Grove City Area School District High School Renovations

Project No: 23-S43-01

ADDENDUM 4

3/21/2024

Proj No. 23-S43-01
Issue Date 02/19/2024
M702
© COPYRIGHT 2024

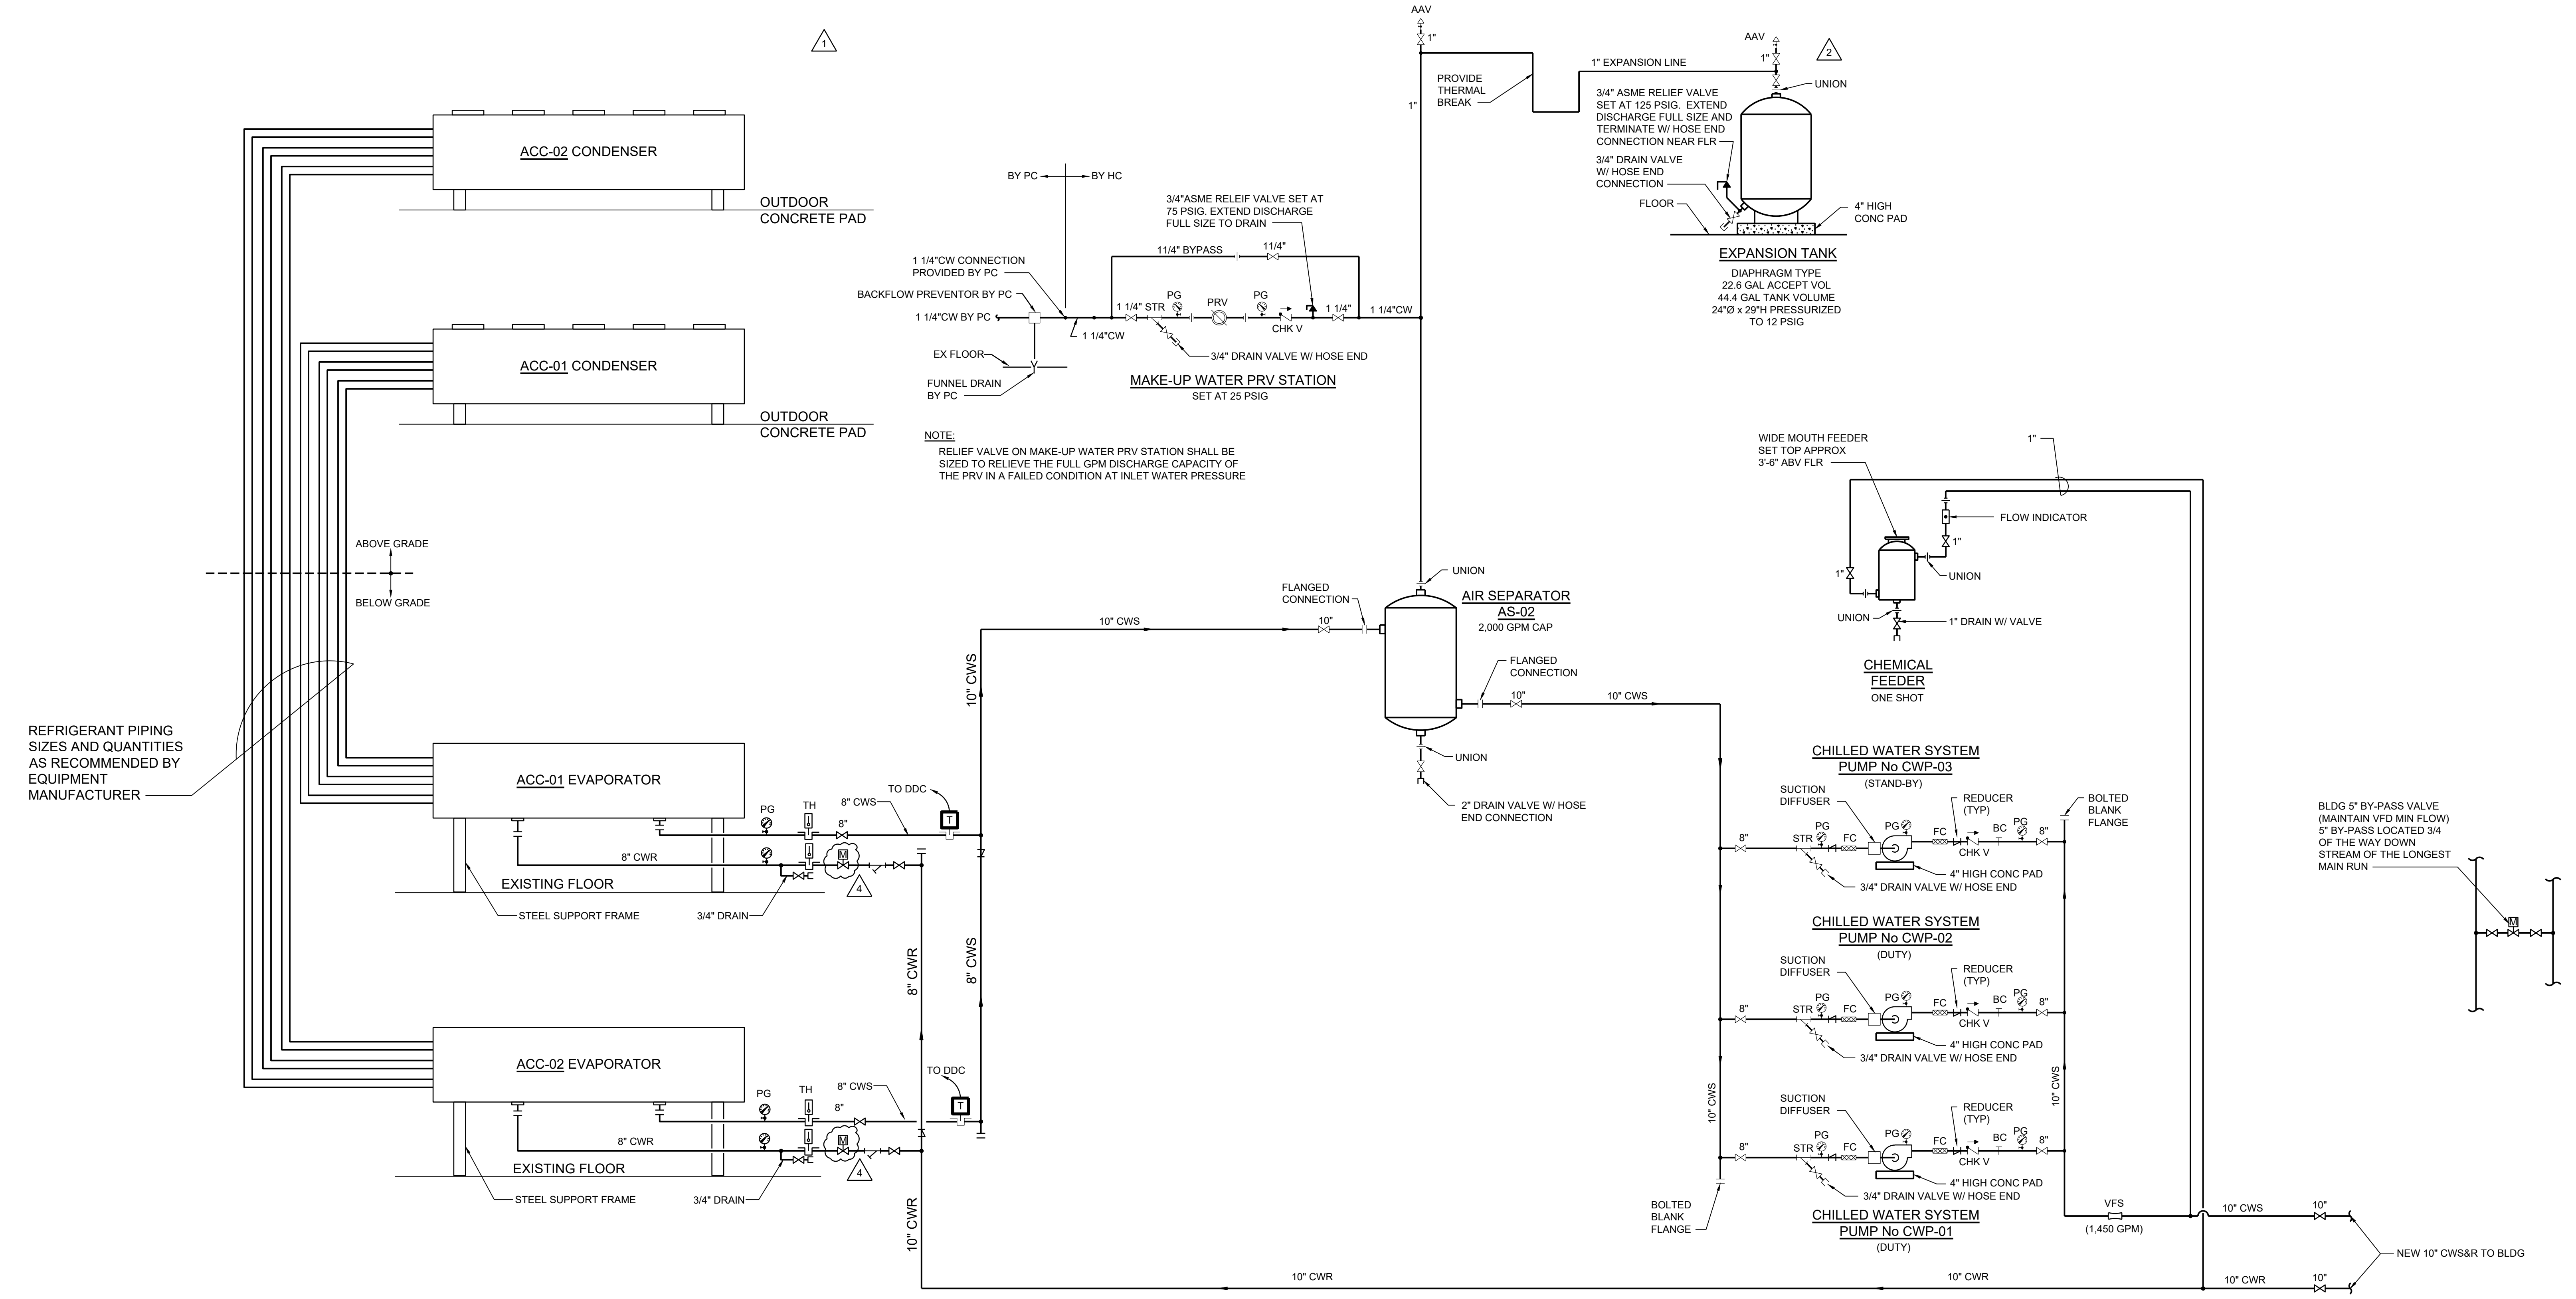
M110	Area G 2nd Flr - Ductwork New Work	Added GRV backdraft damper replacement notes.
M112	Area B 1st Flr - Piping New Work	Added refrigerant vent piping up to roof.
M113	Area C 1st Flr - Piping New Work	Reconfigured piping in Rm 185.
M114	Area D 1st Flr - Piping New Work	Reconfigured piping in Rm 185.
M116	Area F 1st Flr - Piping New Work	Reconfigured pipe drop orientation for UV-07
M121	Base Bid Plans	Added kiln vent exhaust systems.
M301	Roof Plan - New Work	Added new PRV-B07 and refrigerant roof vent.
M405	Enlarged Plans	Added booster pump and piping connection for duct spray assembly.
M501	Details	Modified roof curb responsibility notes.
M502	Details	Modified roof curb responsibility notes.
M503	Details	Modified roof curb responsibility notes and added kiln vent and refrigerant vent details.
M602	Schedules	Added PRV-B07 to schedule and added additional info to kiln vent system.
M702	Diagrams	Added Chiller isolation valves.
